ECR-00991

ARM Radiometer Ventilation Improvements

**Results from Initial Broadband
Radiometer Ventilator Fan
Evaluation**

Operational Observations

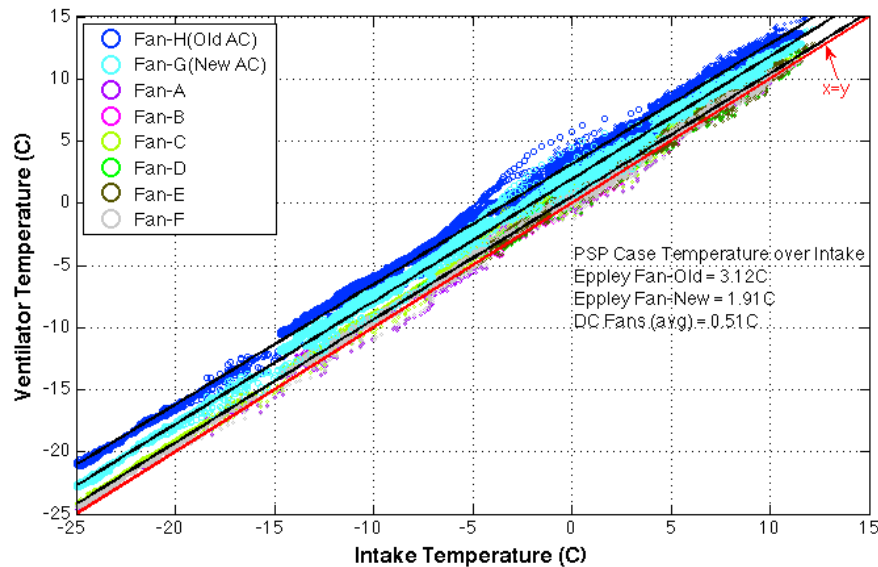
(frost clearing AC vs. DC)

Nighttime Temperature Rise Characteristics

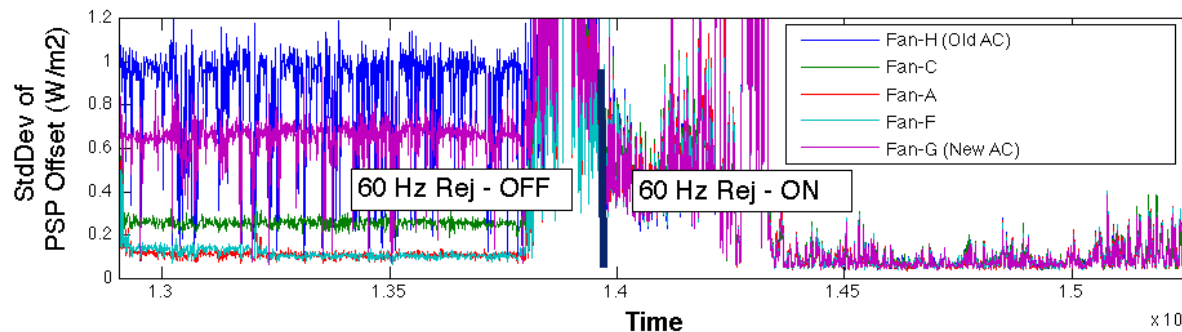
AC: 1.5 – 3°C rise over intake

DC: 0.5 °C rise over intake

Less Induced Noise in PSP Signal (even without 60Hz rejection)

PSP Nighttime Offset vs. Net IR from Co-Located PIR

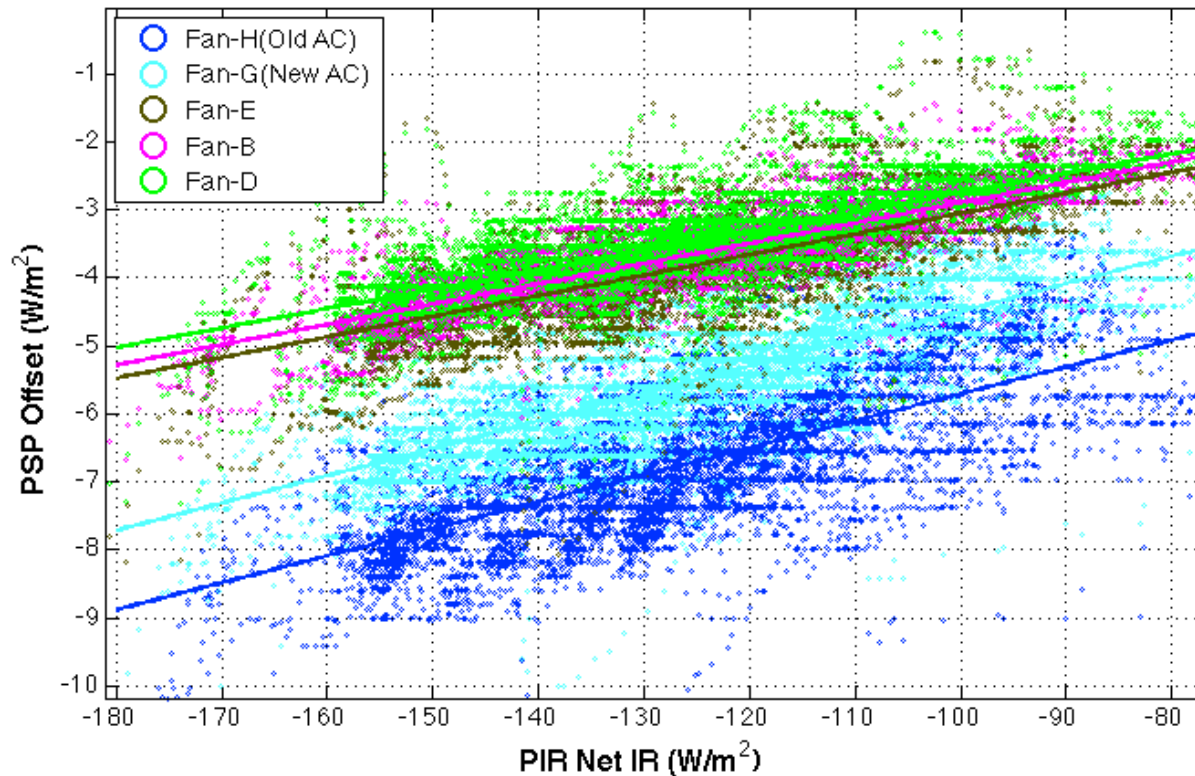
Offset Improvement $\sim 2.5\text{-}3\text{ W/m}^2$

Slight Decrease in net IR responsivity
